MIL-T-38984(USAF)
Amendment 4
16 October 1978
Supersedes Amendment 3
Dated 10 January 1978

MILITARY SPECIFICATION
TEST SET, BOMB PRACTICE TTU-300/E

This amendment forms a part of Military Specification MIL-T-38984(USAF), dated 6 July 1970, and is mandatory for use by the USAF.

FIGURE 1. TEST SET, ECMB, PRACTICE TTU-300/E SCHEMATIC DIAGRAM

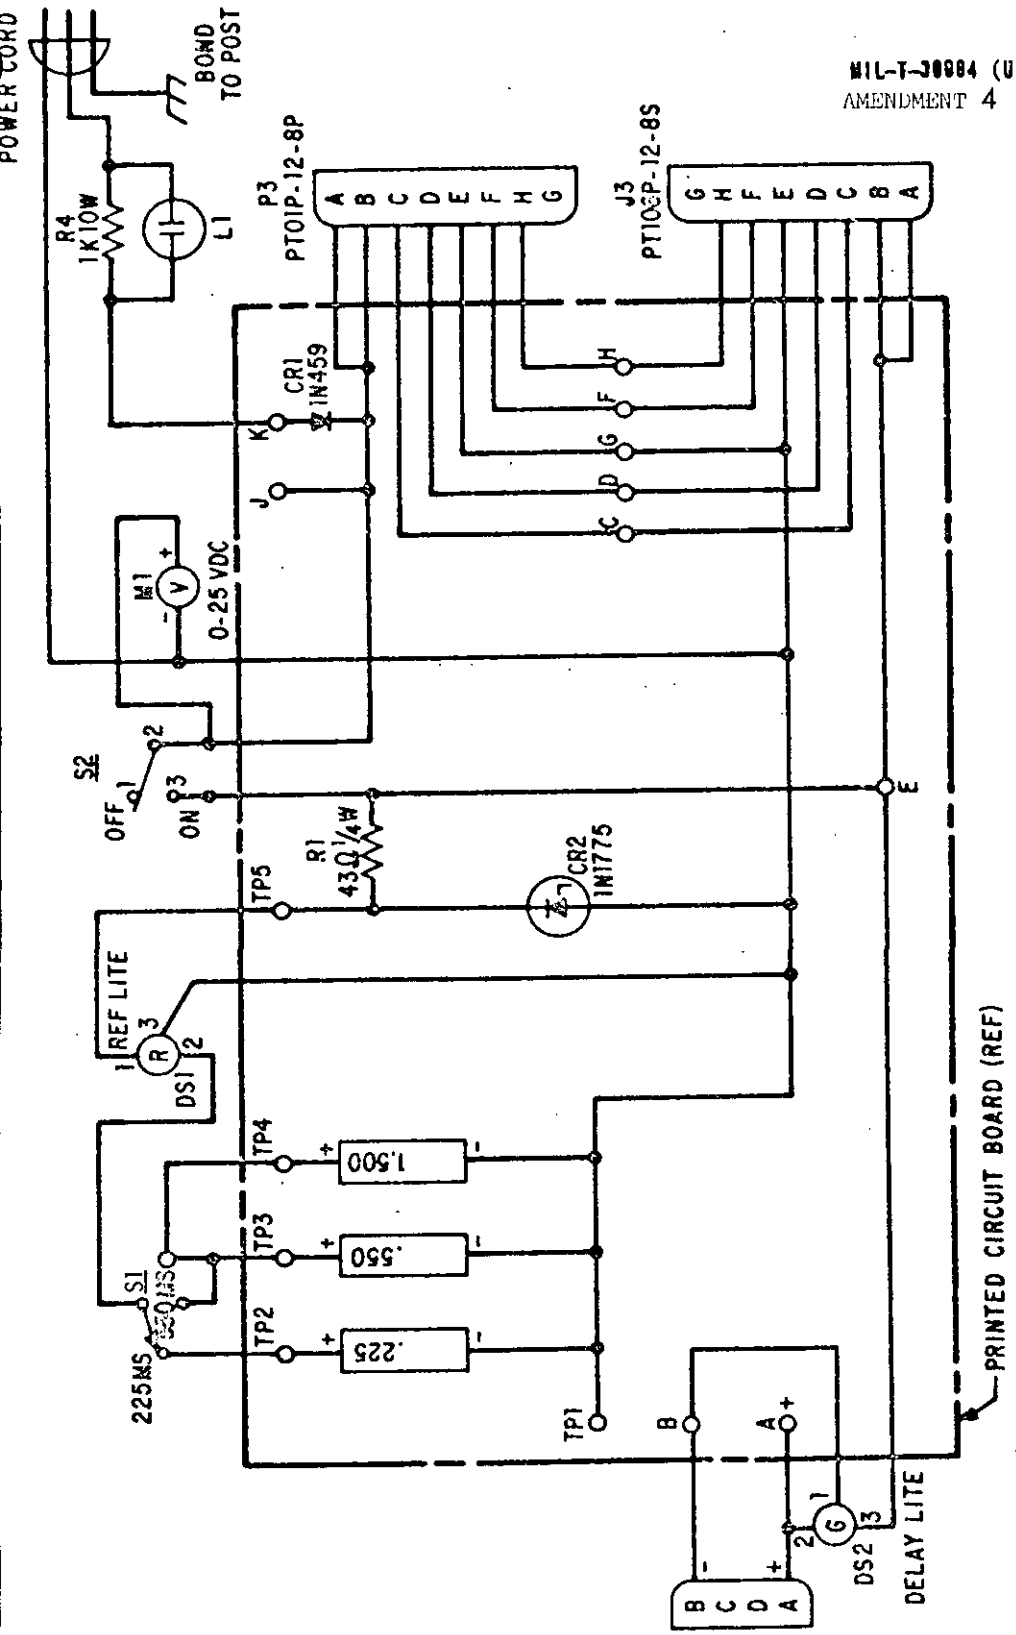
Page 7, Figure 1. Delete, and substitute the attached Figure 1.
